Peach Bottom Atomic Power Station, Unit 2
Renewed Facility Operating License No. DPR-44
NRC Docket No. 50-277

Subject: License Amendment Request - Safety Limit Minimum Critical Power Ratio
Change

GNF Additional Information Regarding the Requested Changes to the Technical Specification SLMCPR

Peach Bottom 2 C19

Figure 1. Current Cycle Core Loading Diagram

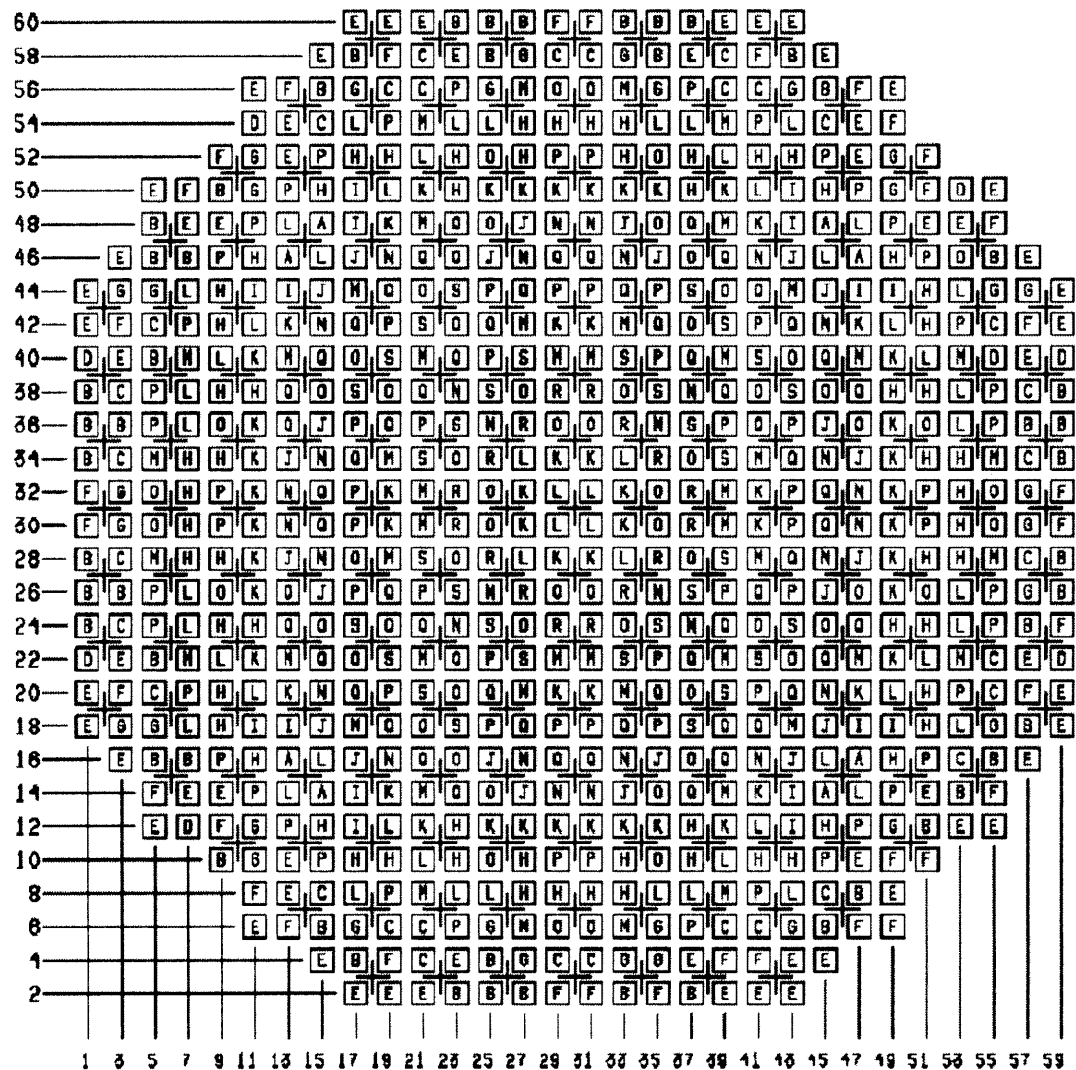
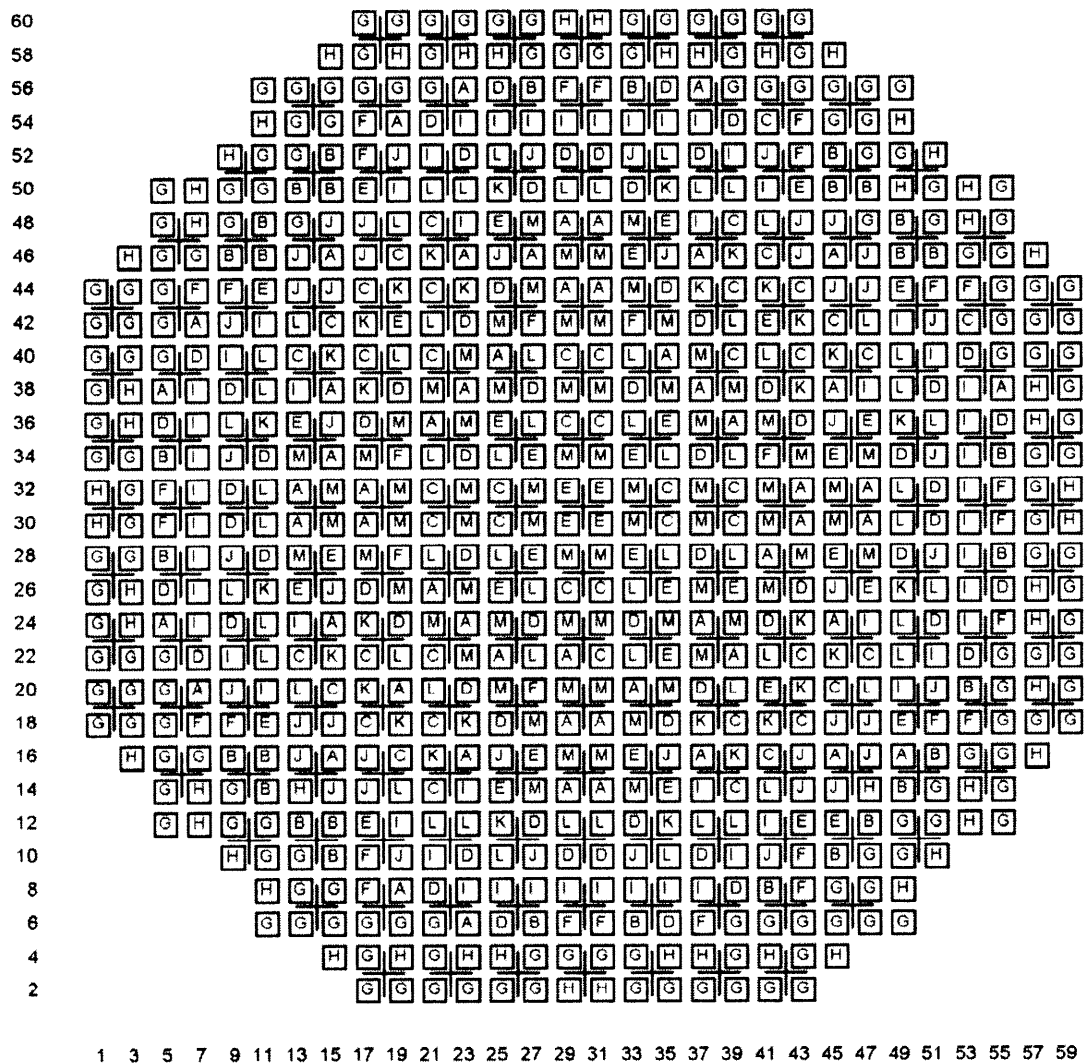
Figures 1 and 2 provide the core-loading diagram for the current and previous cycle respectively, which are the Reference Loading Pattern as defined by NEDE-24011-P-A. Table 1 provides a description of the core.
